**Addendum No. 1**

**Subject: J. Hampton Moore School  
Major Renovation Phase 2B – Interior Renovations  
SDP Contracts No. B-083C and B-084C of 2016/17**

**Location: J. Hampton Moore School  
1100 Tyson Avenue  
Philadelphia, PA 19111**

**This Addendum, dated 7th of November, 2017, shall modify and become part of the Contract Documents for the work of this project. Any items not mentioned herein, or affected by, shall be performed strictly in accordance with the original documents.**

DRAWING NO.  
**E2.02**  
J HAMPTON MOORE SCHOOL

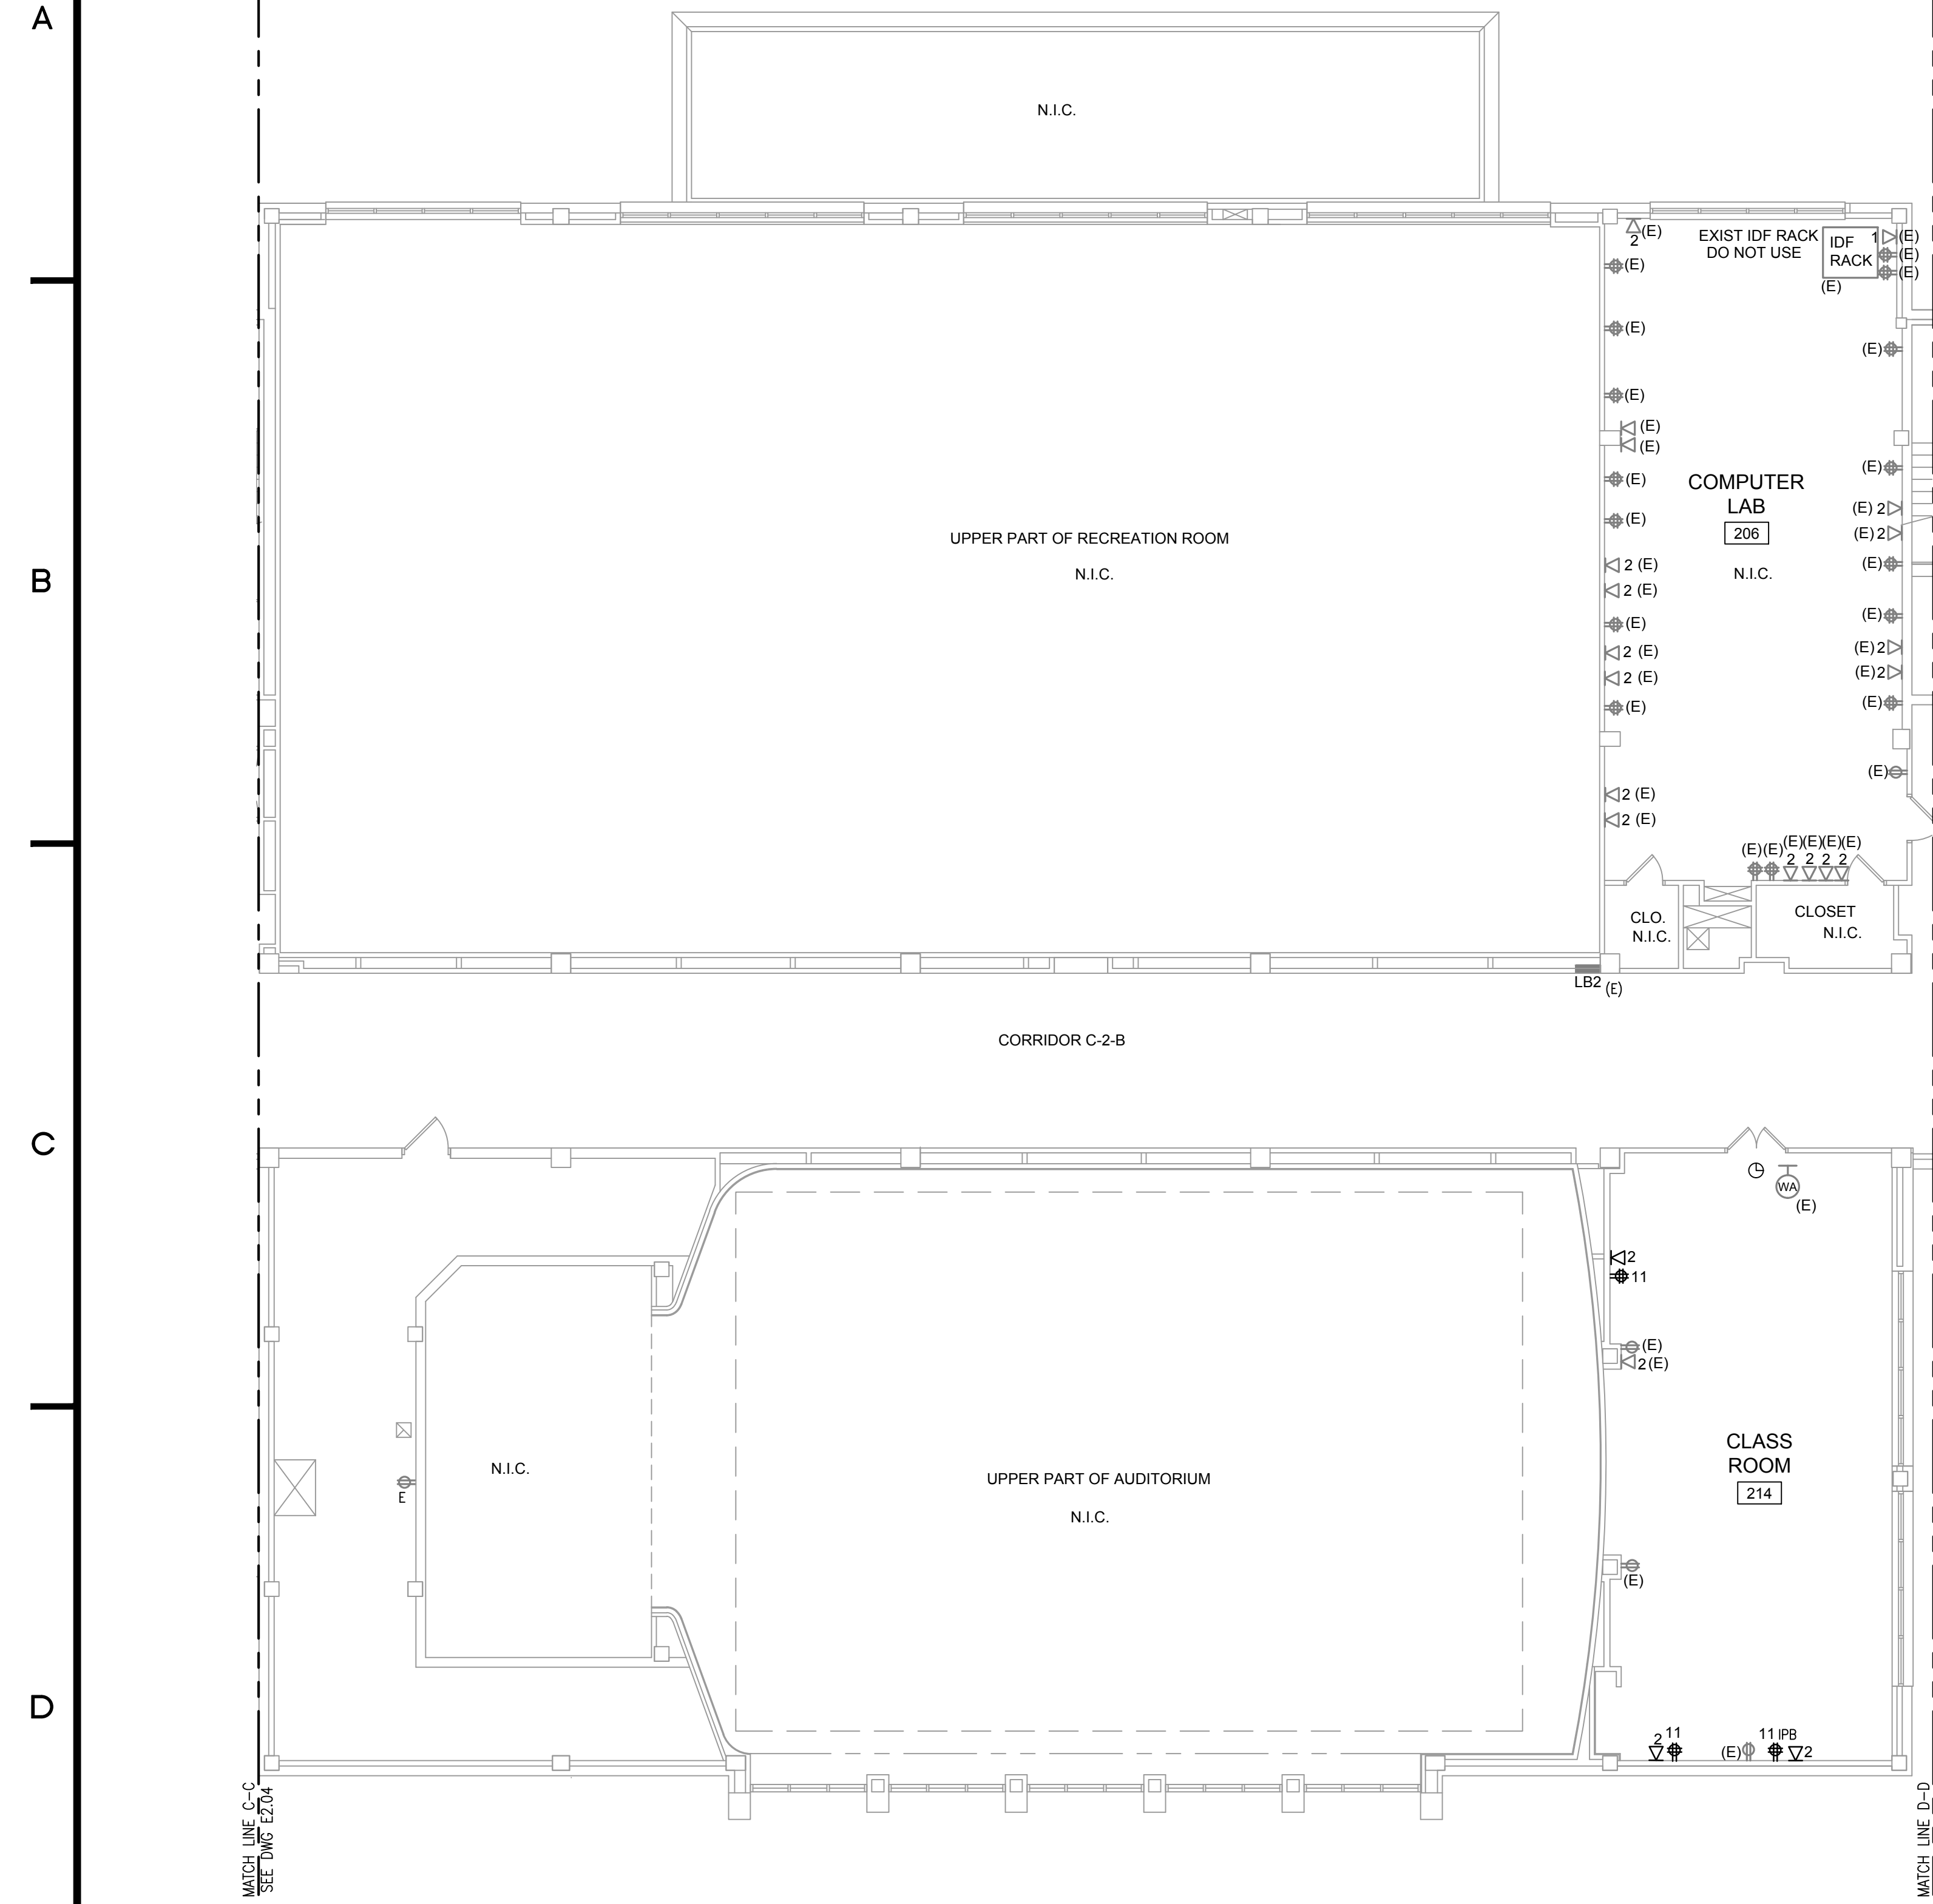
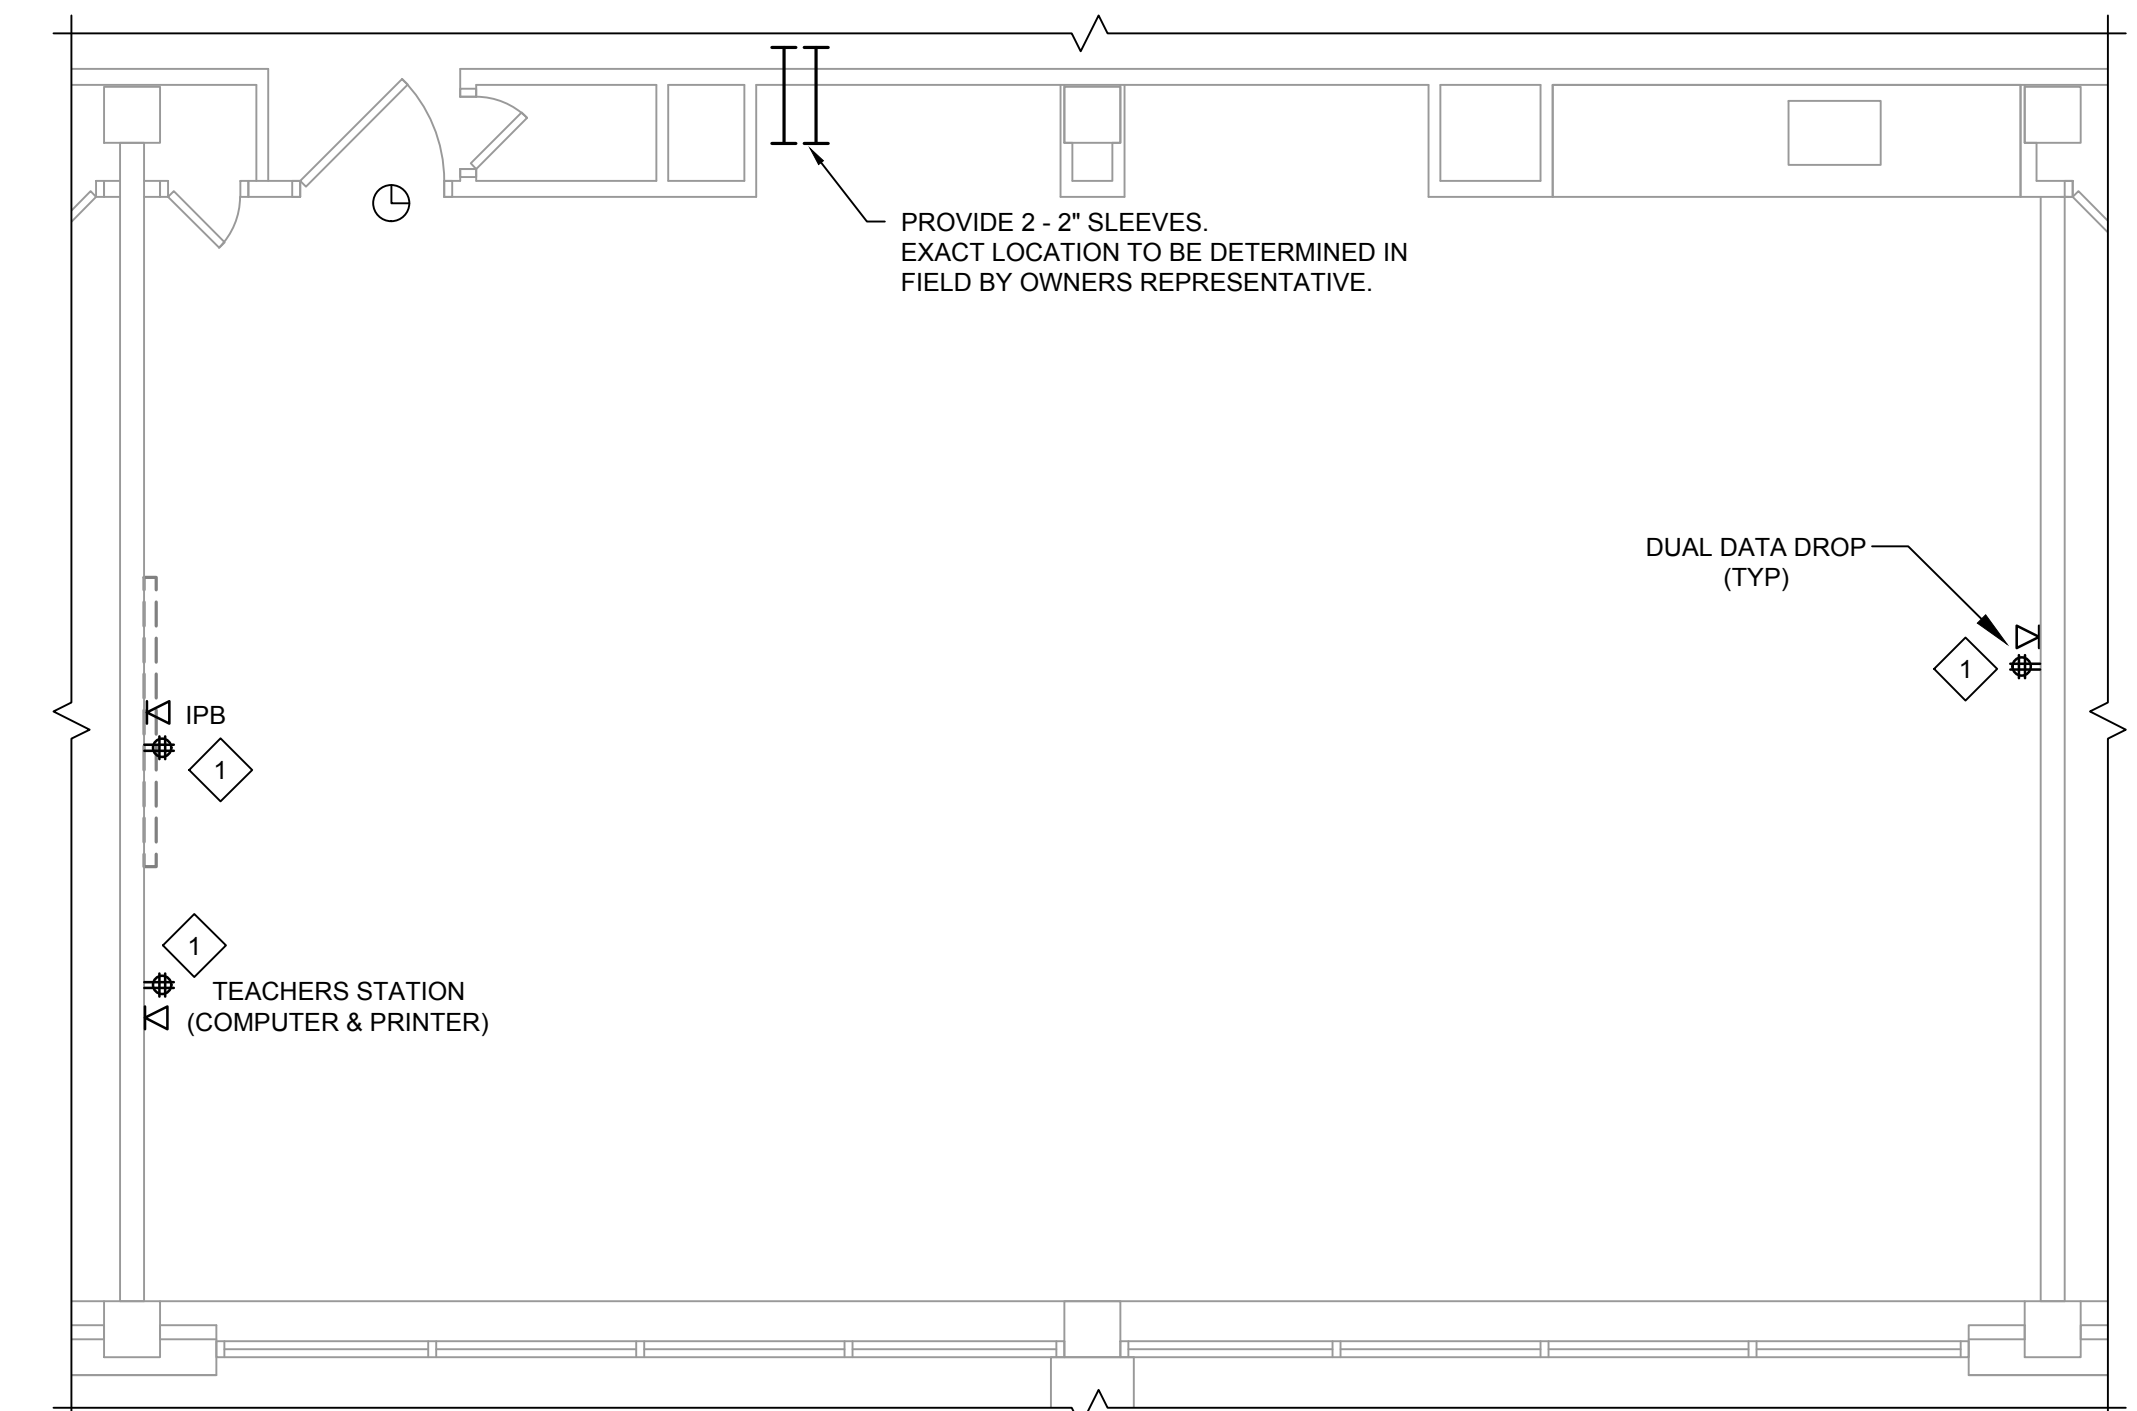
- 1. Drawing E2.02 is revised to include PA speakers and wireless clocks in the new modular building. The modular building is provided by others and is not part of this project.**
- 2. Drawing E5.04 – Detail 3 mounting detail is modified to include power/control cable.**
- 3. Drawing E6.01 – PNL L main rating changed to 225A; PNL L breaker at MDP2 changed to 175A; feeders from MDP2 to PNL L changed to 4 #2/0 & 1-#6 Gnd.**
- 4. Drawings FA.01 thru FA.04 – Notification circuit power booster (NAC) added to symbol legend; Location of NAC have been indicated on plans; Note 4 and 6 have been modified.**

- MODULAR ELECTRICAL PLAN NOTES:**
- MODULAR BUILDING IS BY OTHERS. SCOPE OF WORK IS FOR SPEAKERS AND WIRELESS CLOCKS ONLY.
  - FOR EACH SPEAKER, PROVIDE 20 OR 22 AWG SOLID SHIELDED SPEAKER CABLE, HOME RUN DIRECTLY BACK TO THE MODULAR IDF AND TERMINATE ON A 66 BLOCK. CONTRACTOR SHALL PROVIDE THE 66 BLOCK WITH PROSPECTIVE TERMINALS.
